**STATE SIGNIFICANT DEVELOPMENT:
Section 96(1A) Modification Application**

AUSTRALIAN TECHNOLOGY PARK, EVELEIGH

SSD 7317 MOD 3

Environmental Assessment Report
Section 96(1A) of the *Environmental Planning
and Assessment Act 1979*

Figure 3: The roof top community garden. Source: Applicant's EIS.

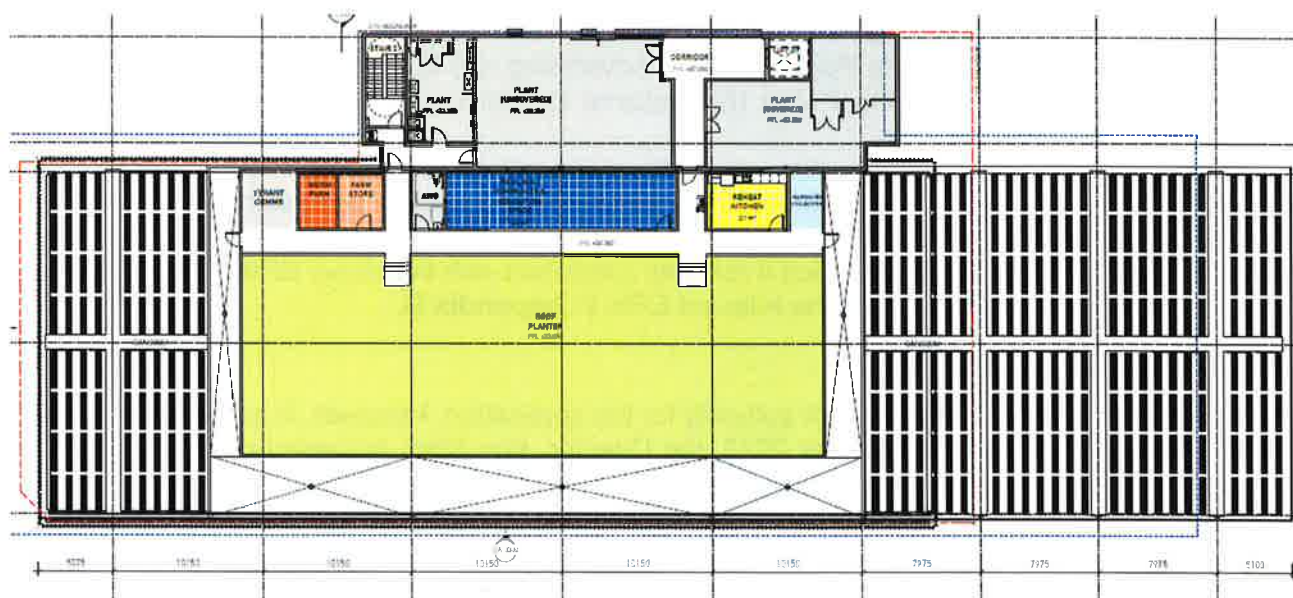
Council considers the community rooftop garden to be a positive addition to Building 3 but noted that insufficient information had been provided as to the design and operation of the space. As part of the RtS, the Applicant provided additional information including a draft plan of management (POM) for the community garden which covers the vision, type of planting, operating hours, access, funding and maintenance arrangements. Council has reviewed the draft POM and considers it to be acceptable.

The Department agrees that the rooftop community garden is a positive addition and believes it would contribute to the appeal of the building to the community, if appropriately managed. The Department recommends a detailed plan of management should be provided once greater detail on the future programming of the community garden is known. The detailed POM should address the matters covered in the draft POM in greater detail and will also need to address other aspects such as community access, community user groups, gardening practises, plot allocation, rostering, safety, waste and water management and mechanisms to encourage community participation.

Figure 8: Proposed ground floor plan (with activated edges shown in green and inactive edges shown in red). Base Image Source: Applicant's RTS.

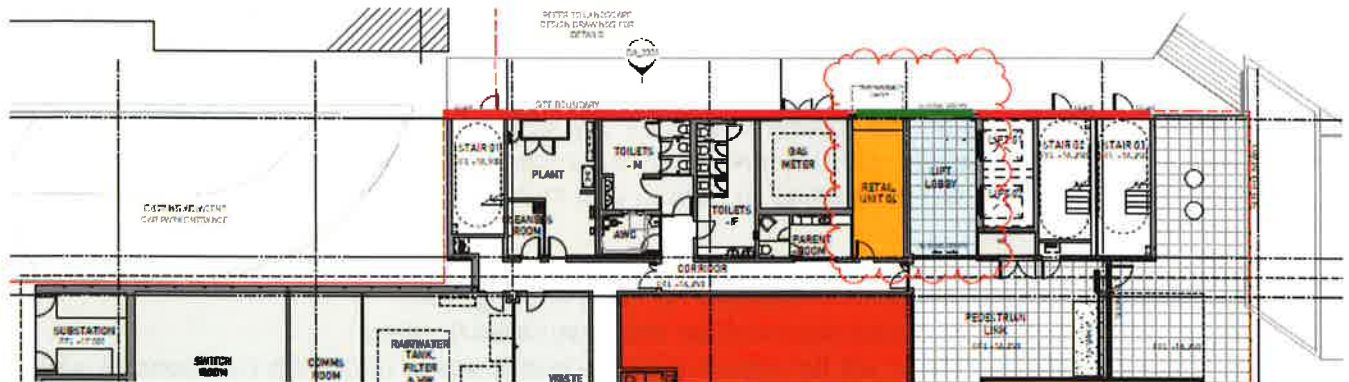
The proposed changes alter the proportion of active uses to the eastern façade facing the Vice Chancellor's Oval, which was a key issue in the Department's assessment of the original proposal and the imposition of Condition B3. 2(b) (refer to **Section 1.3**).

Council raised concerns about the level of activation of the Vice Chancellor's Oval and requested that all options be considered for redesigning the ground floor to reduce the length of the service core and increase opportunities for activation.

The Department has considered the proposal in light of its previous assessment and the concern raised by Council. The Department notes Building 3 has frontages to Davy Road to the west, Central Avenue to the north and the Vice Chancellor's Oval to the south and east.

The Department acknowledges that Building 3 requires a high level of servicing (in relation to its relative size) to achieve the ESD targets for a zero-emissions building, and the approved remediation strategy does not allow for a basement structure. Therefore the majority of this servicing is provided on the eastern portion of the ground floor. In addition, three independent fire stairs are required to service the community, commercial and child care uses within the building which limits the ability to reduce the length of the service core as suggested by Council.

In addition, noting the prominence of the other three frontages and higher levels of pedestrian activity in these areas, the Department agrees with the Applicant that the eastern elevation fronting the Vice Chancellor's Oval is the most appropriate location for the bulk of the servicing.

Notwithstanding, the Department is satisfied that activation of the eastern frontage has been maximised through:

Figure 10: Western elevation to Davy Road, as proposed. Source: Applicant's EIS.

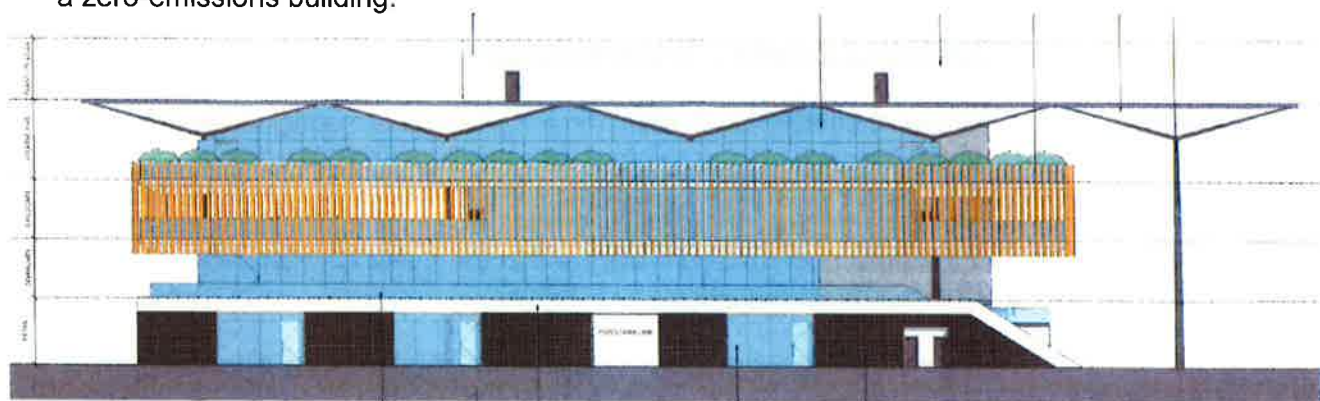
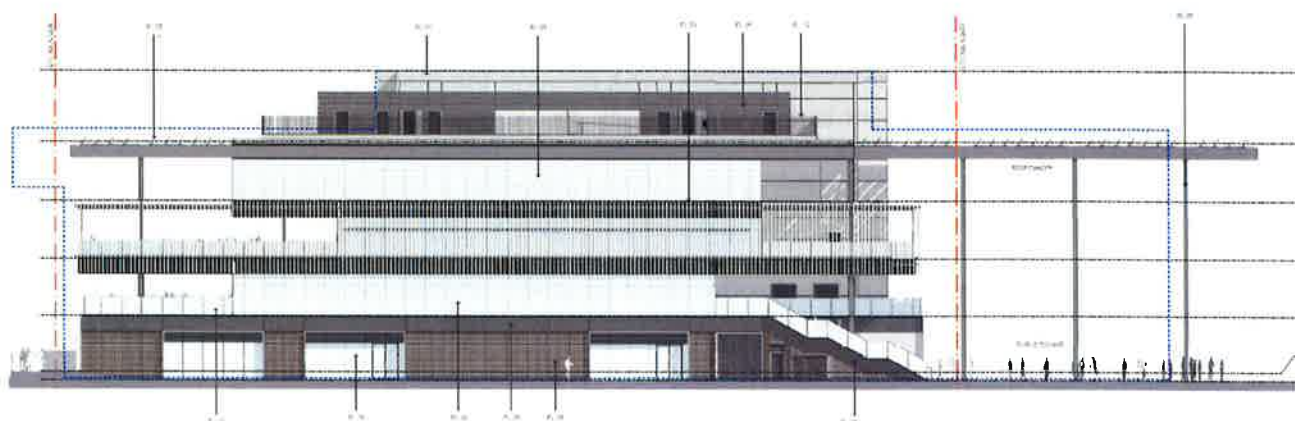
Council raised concern about the level of activation on the western elevation of the building on Davy Road, suggesting that increasing the level of glazing to Davy Road could provide greater opportunities for passive surveillance.

The Department notes Council's concern about the Davy Road frontage and notes this is a primary street address for Building 3. The Department notes that 40% of the frontage features glazed retail shop fronts which is consistent with the previously approved plans for Building 3. In addition, the remainder of the frontage will be finished in gabion wall treatment which provides visual interest to the blank facades.

The Department considers the level of activation is reasonable given:

- it is equivalent to that previously approved on the Davy Road frontage
- the south end of Davy Road will be activated by the public space under the roof canopy, which has the auditorium entrance and a retail tenancy, and is designed to encourage people to linger, gather and meet
- a larger than usual quantity of servicing is required on the ground floor due to the target to achieve a zero-emissions building.
